2BHK

TOWER- E (2,3&4 UNITS)

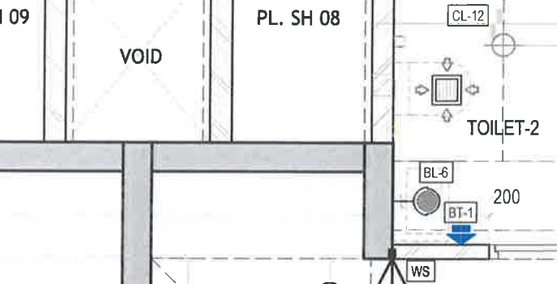
BL1 TO SHIFT AS THE DINING NICHE WILL BE UNDER DARK ZONE.

MAKE THE PELMET MATCH LIGHTER FOR VISIBILITY.

CHECK LOCATION.

FURNITURE LINES NOT VISIBLE.

(GENERAL PT) ARE THE DIM. UP TO CENTRE OF SB OR CORNER EDGE??

NUMBER THE SB FOR CHIMNEY HOB.

BEDROOM ELEVATION

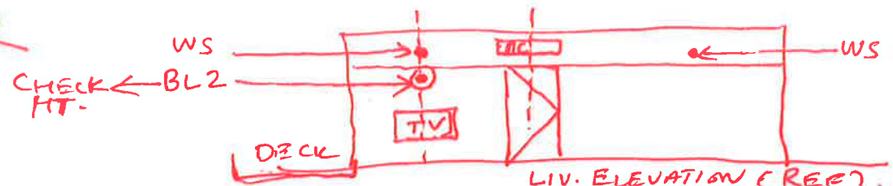
CAN K5 BE SHIFTED ON SHORTER WALL

AVOID SB ON SHEAR WALL. SHIFT SB EA UPWARDS

SHIFT WS LOCATION @ TV CENTER (BL2, TV & WS in a line above each other)

CENTERED ON DOOR

AVOID SHEAR WALL. SHIFT ON SHORTER WALL WITH SB @ 1250

TV, AC & SPRINKLER TO BE @ BED CENTER
